CITY OF DELRAY BEACH

1993 · 2001 · 2017							
HISTORIC PRESERVATION BOARD STAFF REPORT									
	Sundy Village								
Meeting	File No.	Application Type							
September 4, 2024	2024-162	Certificate of Appropriateness and Master Sign Program							
	REQUEST								
The item before the Board is cons development known as Sundy Vi		aster Sign Program (2024-162) for the Square Historic District.							
	GENERAL DATA								
Owner: Sundy Village West, LLC Agent: Jared Hochman Location: 25 SW 1 st Avenue PCN: 12-43-46-16-Q6-001-0020 Project Name: Sundy Village Project Size: 6.902 Acres Project Zoning: OSSHAD, OSSI LUM: HMU (Historic Mixed Use) Historic District: Old School Squ Adjacent Zoning: • North: OSSHAD, OSSI • East: OSSHAD, OSSI • East: OSSHAD, CBD • South: CF, OSSHAD • West: CF, CBD, RM Existing Land Use: Commercia Proposed Land Use: Commercia	HAD w/ CBD Overlay Jare Historic District HAD w/ CBD Overlay	<image/>

SUNDY VILLAGE MASTER SIGN PLAN

Free – Standing Monument Signs (11) (10 – Historic Restaurant, and 1 - Site Name)

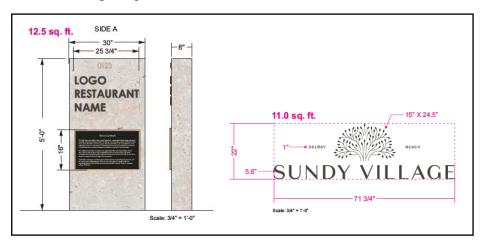
There are concerns with the material, type, and size of proposed signs in association with the historic structures along S. Swinton Avenue. The proposal includes ten 5' tall stone, ground mounted, monument signs to be located in the front and rear of the historic structures. The Design Guidelines state that sign material should be compatible with the construction materials of the buildings and the buildings are either wood frame or stucco exteriors. Additionally, these structures were originally constructed as residences and later converted for commercial use. The recommended approach for the design of proposed signage for structures that were converted from residential use is to incorporate materials from the structure into the design of the sign (for example a wood sign would be an appropriate choice for a wood frame structure). Further, the use of compatible signage would aid in communicating the historic nature of the structures where the site is largely comprised of new construction.

While the stone monument signs might be considered consistent with the overall sign proposal across the Sundy Village site, there are concerns that these 10 signs may not meet the design and historic requirements of the Design Guidelines. It is noted that city staff provided this guidance to the applicant

The proposed signage adjacent to the historic structures includes the use of stone monument signs where the historic structures are wood frame with wood siding or stucco exteriors. The proposed signs represent the introduction of a different architectural style and material, which may not be considered appropriate for the Frame Vernacular and Bungalow architectural styles of the historic structures. Compliance with this standard can be made by utilizing signage styles with appropriate materials to be visually compatible with the style of the historic structures.

T3 - Tenant Blade - Retail Tenants UNITED CONTRACTOR TENANT 24" **III** NAME UIIII -----********* luann TENANT 24" Scale: 1" = 1'-0" **4.0 sq. ft.** FABRICATED ALUMINUM HANGING BLADE SIGN WITH FAUX FINISH. MOUNTS TO WALL AT 9'-0" ABOVE GRADE. FONT: PANAGRAM MEDIUM FLORI SIGN GROUP

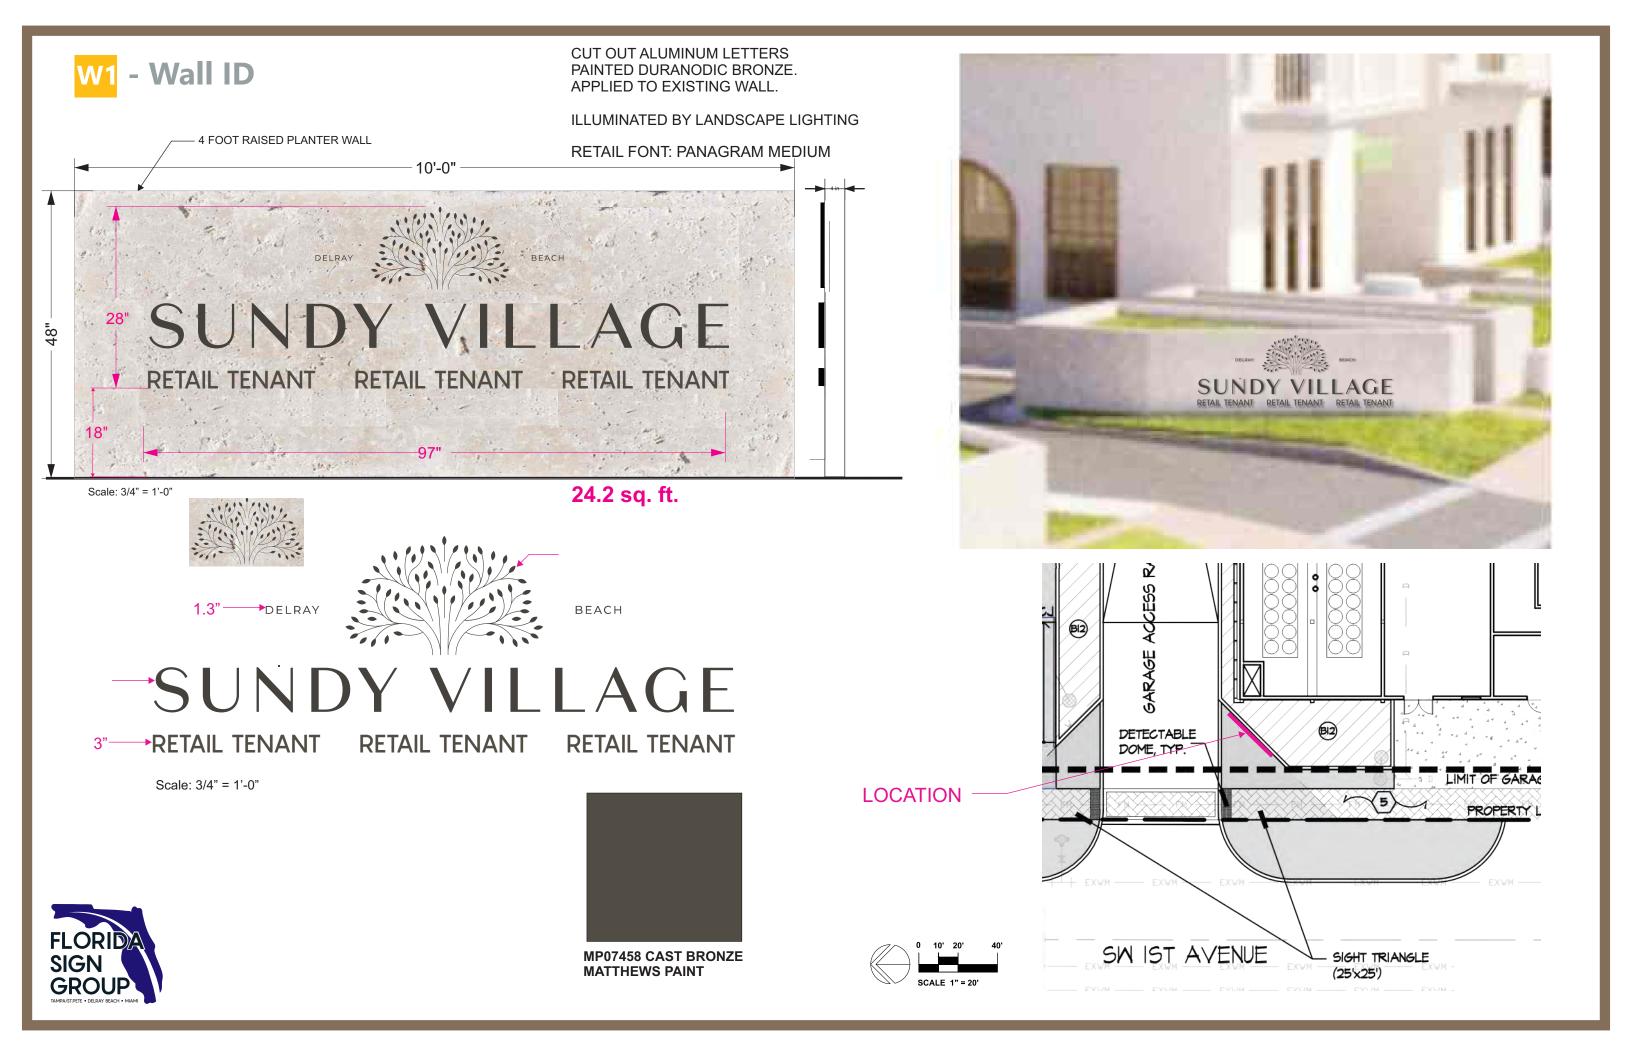
Since a portion of the site is within the OSSHAD with CBD Overlay, Section 2(b) above is applicable. There are a series of projecting signs placed on the face of the arcade of Buildings 1, 2, & 3 and may not extend from the exterior face of an arcade. An added site plan technical item is that the proposed projecting signs be changed to be compliant with the LDRs.
